EPRI (2004, 2006) Ground-Motion Model (GMM) Review Project

**Responses to NRC Review Questions
and Comments Dated July 3, 2013**

July 30, 2013

Figure 1-1: Comparison of evolving estimates of the components of aleatory variability for 10 Hz pseudo-spectral acceleration. Top plot shows standard error of inter-event variability, τ , in natural log units and bottom plot shows standard error of intra-event variability, ϕ , in natural log units.

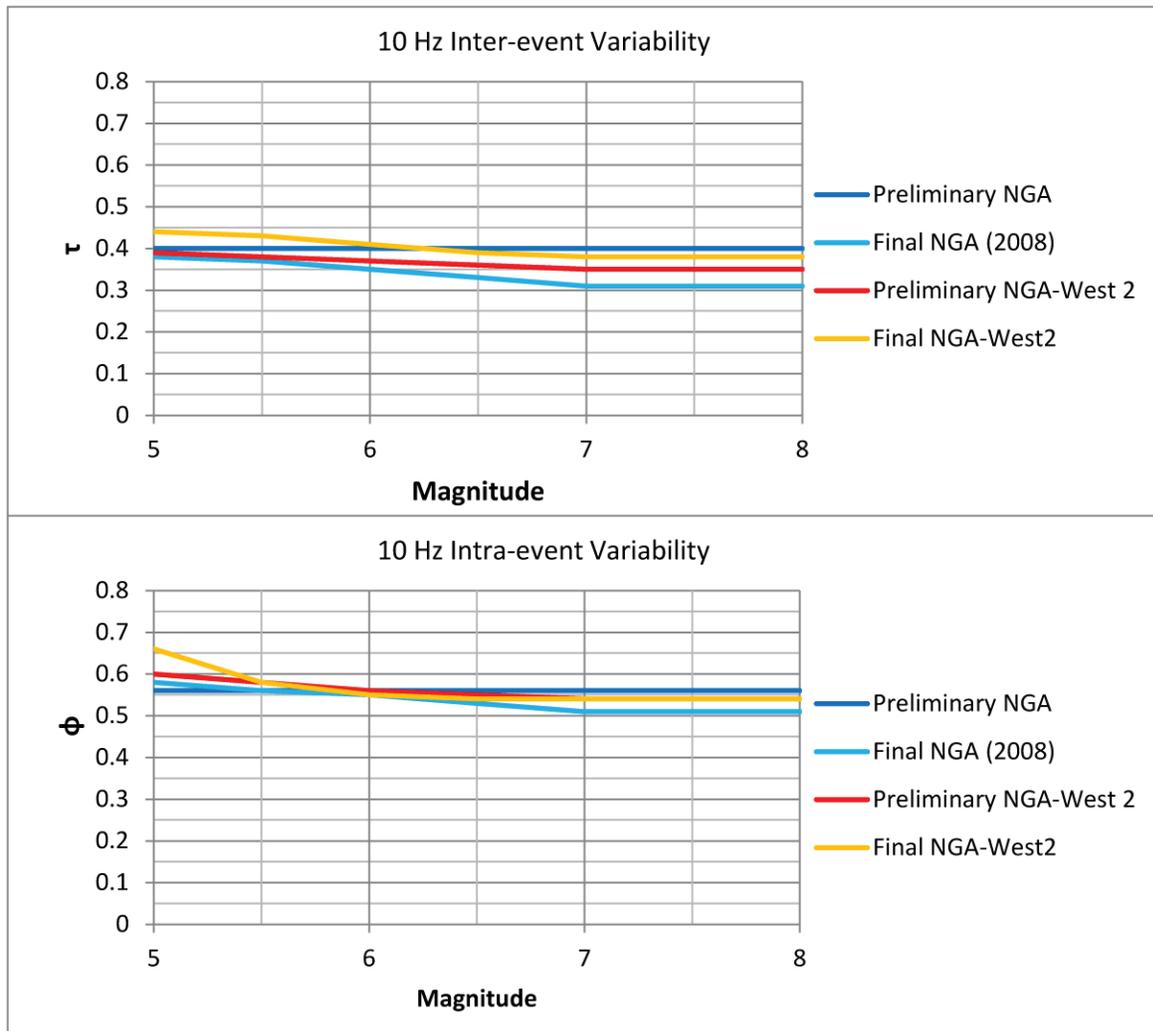
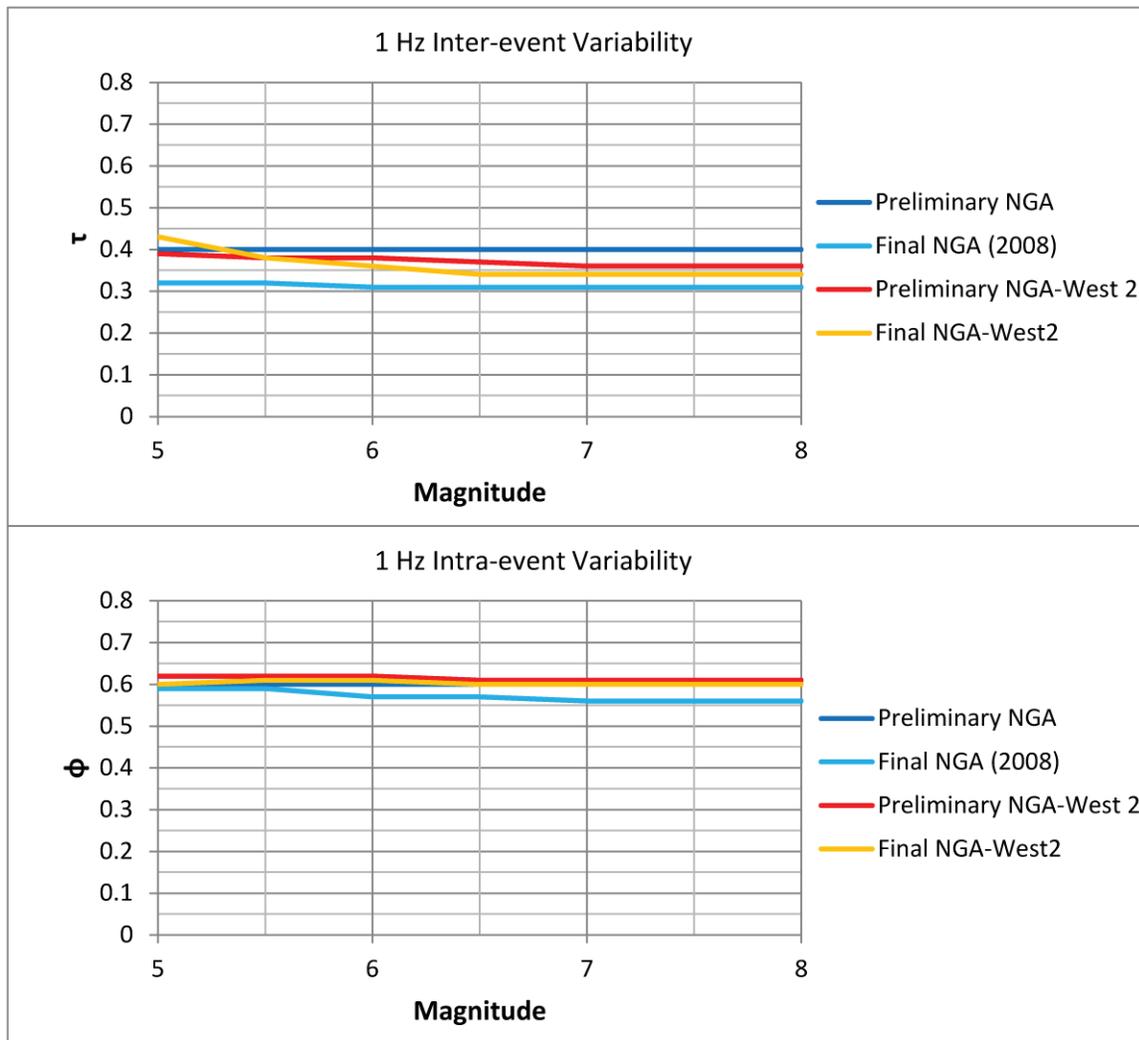
Question 1: Section 7.10 contains a discussion of the development and rationale for the updated aleatory uncertainty (sigma) model used in the 2013 GMM update. The EPRI (2006) model for aleatory uncertainty was based on preliminary PEER NGA models for sigma from active tectonic regions with adjustments that account for differences between active and stable tectonic regions. The model for sigma used in the present study is again based on preliminary aleatory uncertainty models that have been under development for active tectonic regions as part of the NGA-West 2 project. Subsequent to the publication of the EPRI (2006) aleatory variability study, the final NGA-West sigma models were published and differed significantly from those referenced in the EPRI study. Specifically, magnitude dependence in sigma was incorporated into the models. Considering the preliminary state of the NGA-West 2 sigma models and the potential for future modifications, discuss the use of the NGA-West 2 sigma models as the basis for the aleatory uncertainty model used for the EPRI 2013 CEUS GMM.

One of the main conclusions of the EPRI (2006) study was that the empirical data set of strong motion recordings for active tectonic regions provides a better constraint on the aleatory variability of CEUS ground motions than the set of estimates based on parametric variability and limited CEUS data used to develop the EPRI (2004) aleatory variability model. EPRI (2006) used an average of the available values from the preliminary models developed during the PEER NGA Project to estimate the components of aleatory variability. As these values were based on statistical estimates from the analysis of observed data, they are subject to fluctuation as data sets are added to and modified and the associated models for median ground motions evolve. Figures 1-1 and 1-2 compare the average values of the estimates of the components of aleatory variability from the published versions of the four 2008 NGA GMPEs to the preliminary values used by EPRI (2006) for pseudo-spectral acceleration at 10 Hz and 1 Hz, respectively. As noted in the question, the final 2008 aleatory variability models incorporated magnitude dependence to some extent, while the preliminary models did not. This change accounts for some of the differences between the preliminary and final estimates, especially at large magnitudes.

The variation in estimates of aleatory variability as a function of data sets and analysis methods is well documented (e.g., Strasser et al., 2009). Therefore, it is not surprising that the major expansion of the size of the database in the NGA-West 2 Project, along with revisions in the associated median GMPEs, led to changes in the estimates of aleatory variability from those presented in the 2008 NGA models. As described in Section 7.10 of the report, the averages of the preliminary estimates of the components of aleatory variability from the NGA-West 2 Project were used to develop the update to the EPRI (2006) aleatory variability model. These values are also shown on Figures 1-1 and 1-2. Finally, completion of the NGA-West 2 database and finalized median models (as submitted to *Earthquake Spectra for an upcoming special issue*) resulted in changes in the estimates of the components of aleatory variability, as shown on Figures 1-1 and 1-2. The differences between the preliminary and final estimates of aleatory variability from the NGA-West 2 Project are generally less than the differences between the preliminary and final results from the 2008 NGA project, indicating that the preliminary results were in a more finalized state. Furthermore, the differences between the preliminary and final

estimates of aleatory variability from the NGA-West 2 Project are comparable to or smaller than the statistical uncertainty in estimating the variance parameters.

Along with the evolution of estimates of aleatory variability from empirical data, the approach to treatment of aleatory variability in PSHA is evolving. As described in Al Atik et al. (2010) and Rodriguez-Marek et al. (2013), the variability in recorded ground motions can be broken down into a number of contributing components, two of which are variability in response from site to site and variability in amplification at a given site. The accepted procedures for site-response analysis in Regulatory Guide 1.208 involve incorporating the uncertainty and variability in site response into the assessment of hazard at the foundation level of safety-related structures. As total aleatory variability estimated from empirical ground-motion data already includes a component related to site-response variability, there is a degree of double counting of uncertainties in using this aleatory variability to compute the reference hard-rock hazard.

Rodriguez-Marek et al. (2013) indicate that PSHA analysis is moving toward the use of what is termed “single station” sigma, in which the component of site-specific variability in site response is removed from aleatory variability used to compute the reference hard-rock hazard, and then is reintroduced in assessing the ground-motion hazard at the foundation level using site-specific information and its associated uncertainties. Rodriguez-Marek et al. (2013) demonstrate that values of single-station sigma and, in particular, the intra-event component, single station phi, are more stable across tectonic regions, across different tectonic environments, and among different investigators than are estimates of total aleatory variability. These results indicate that the single-station sigma concept may prove to be a more stable approach for developing aleatory variability models for PSHA.

Based on the above discussions, we conclude that the updated EPRI (2006) aleatory variability model presented in Section 7.10 of the report appropriately represents current estimates of the appropriate level of aleatory variability for computing the reference rock hazard at nuclear plant sites located in the CEUS. Although they are based on preliminary results from the NGA-West 2 Project, the values are generally within the statistical estimation uncertainty of the results from the finalized NGA-West 2 GMPEs. As demonstrated in Section 7.10 of the report, incorporation of multiple models to represent this level of statistical uncertainty is not needed for calculation of mean hazard. In addition, because the values are based on total observed aleatory variability, they are conservative when used in a ground-level hazard framework that incorporates additional uncertainty and variability in site response.

Figure 7.3.1.2-4 Adjusted and original response spectra for an M 4.6 earthquake recorder at rock station ET.SWET at a distance of 85 km

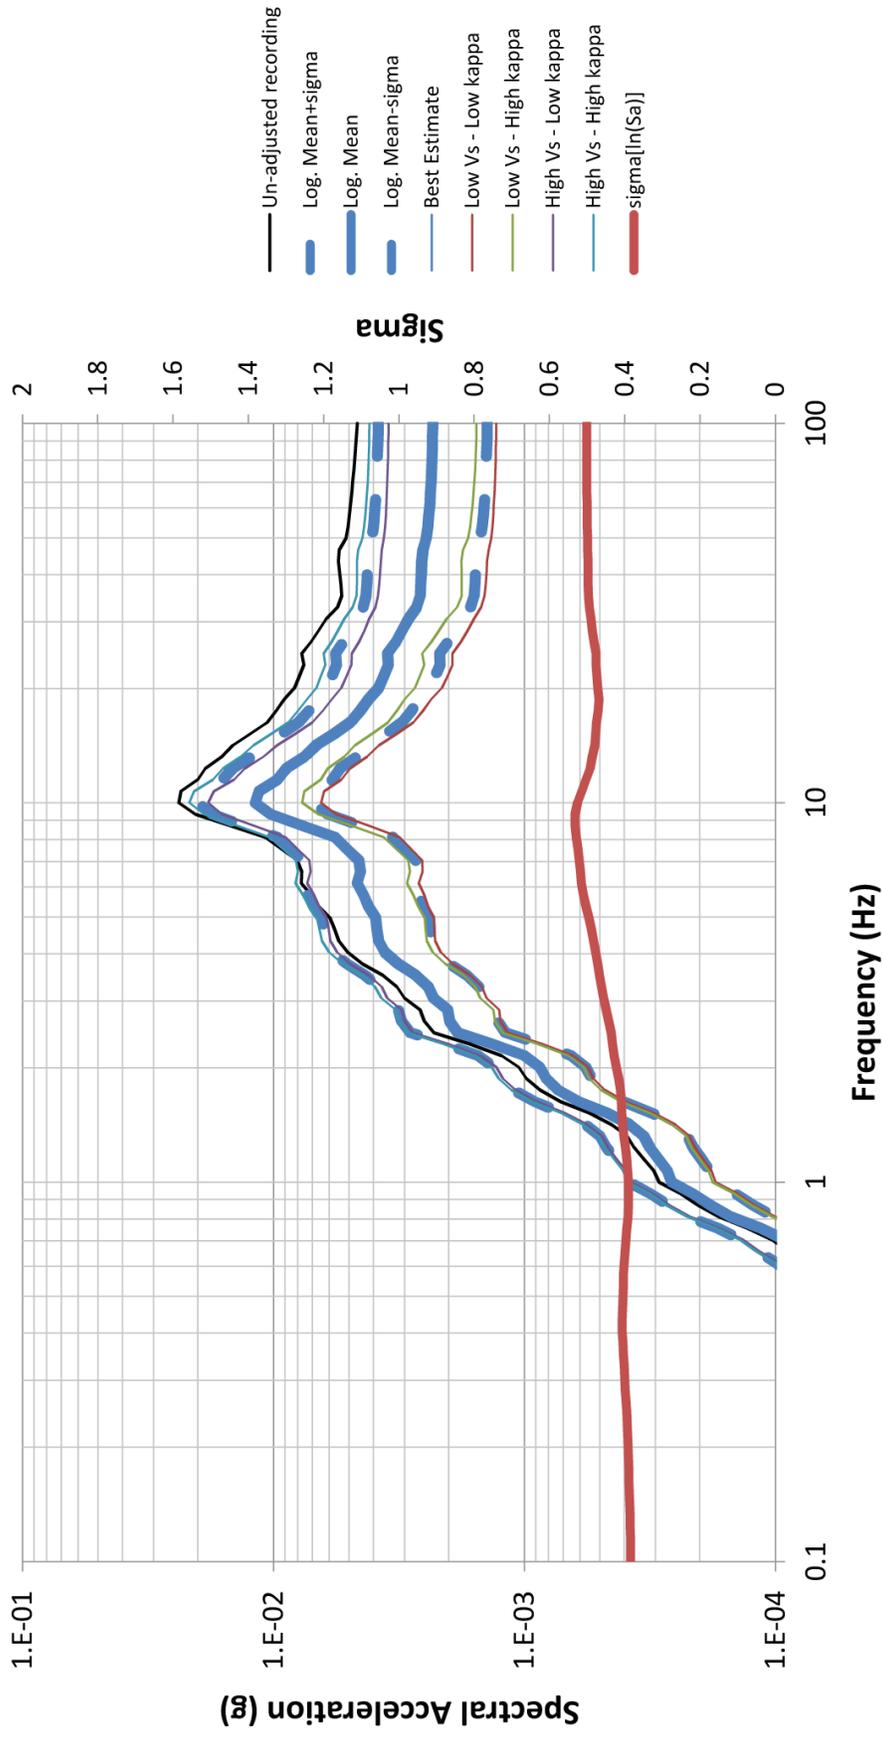
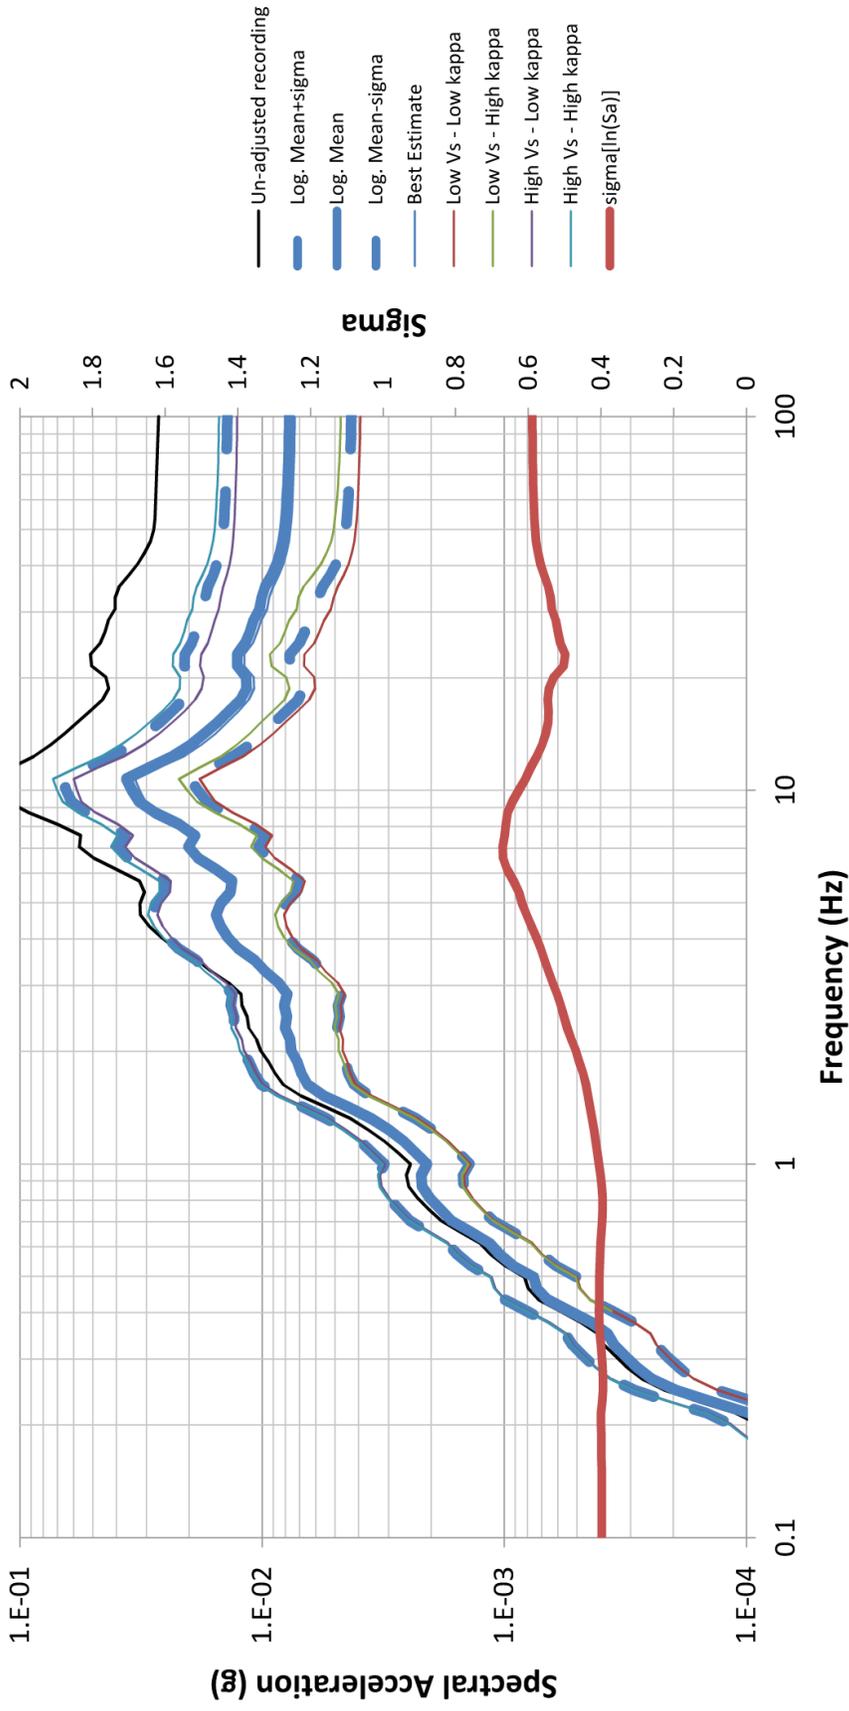
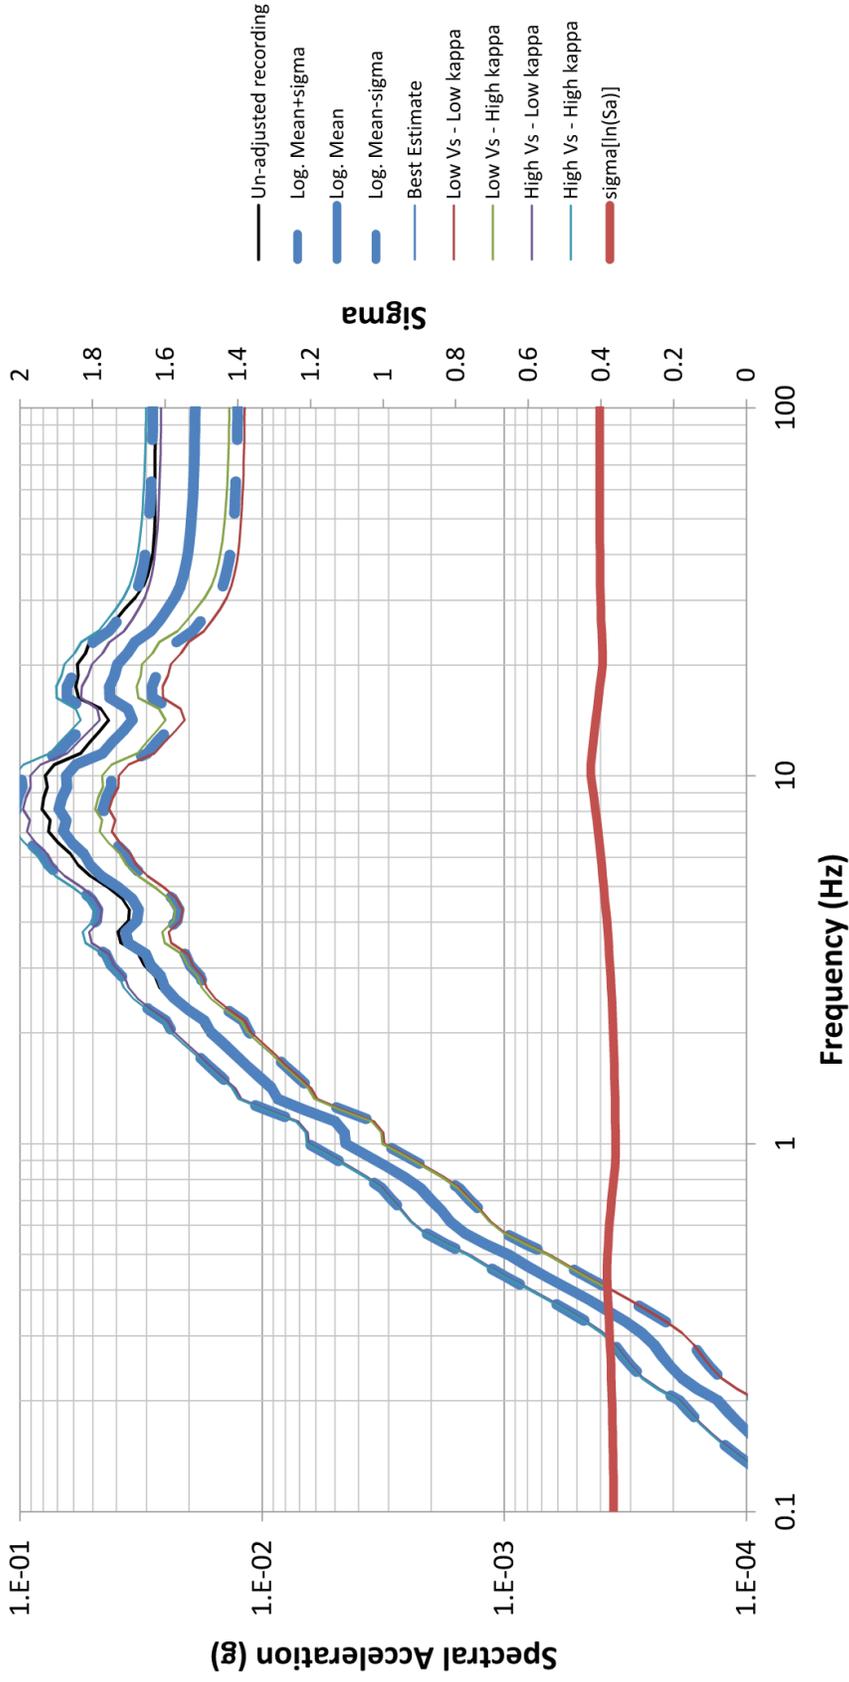
Question 3a: *As described in Section 7.3 of the report, for sites located on stiff soil or soft/intermediate rock conditions site corrections were estimated. For sites with measured near-surface shear-wave velocity profiles an analytical approach was used to calculate site-specific amplification functions. For sites without measured near-surface shear-wave velocity profiles an empirical approach to estimate site correction factors for broad site classes was employed. The results obtained from these calculations were then used to correct the observed data prior to estimating the quality of the fit of each GMPE used in the updated GMM. There is significant uncertainty in estimating and extrapolating the shear-wave velocity profile to depth for the analytical approach and in classifying the sites in the empirical approach. The report recognizes these uncertainties and attempts to estimate them and propagate them through the process (as described in Section 7.4.3). However, the degree to which these uncertainties influence the final choice of weights in the model is not made clear. Please discuss and document the impact of the uncertainties on the final model.*

Response: In order to understand the effect of the uncertainties in site correction on the calculation of weights, it is useful to concentrate first on the diagonal terms of the covariance matrix, which are the most important terms, and consider the effect of the off-diagonal terms later. If the off-diagonal terms are neglected (resulting in a diagonal covariance matrix Σ_{ϵ} in Equation 7.4.3-5), the inverse of Σ_{ϵ} is also a diagonal matrix containing the reciprocals of the corresponding main-diagonal terms, so that Equation 7.4.3-5 may be written as

where ϵ_{ijk} is the adjusted residual for GMPE i , earthquake j , and station k ; $\sigma = \sqrt{\tau^2 + \phi^2}$ is the aleatory standard deviation for the rock motion (Section 7.10); and $\sigma_{C,jk}$ is the uncertainty in the adjustment factor for earthquake j at station k . In the analytical approach, $\sigma_{C,jk}$ has typical values of 0.4 to 0.7 (see Figures 7.3.1.2-4 through 7.3.1.2-6), which makes this term

comparable in size to $\sigma = \sqrt{\tau^2 + \phi^2}$. In the empirical approach, $\sigma_{C,jk}$ has typical values of 0.11 to 0.17 for soft-soil sites and 0 for intermediate- and hard-rock sites (see Table 7.5.2-1).
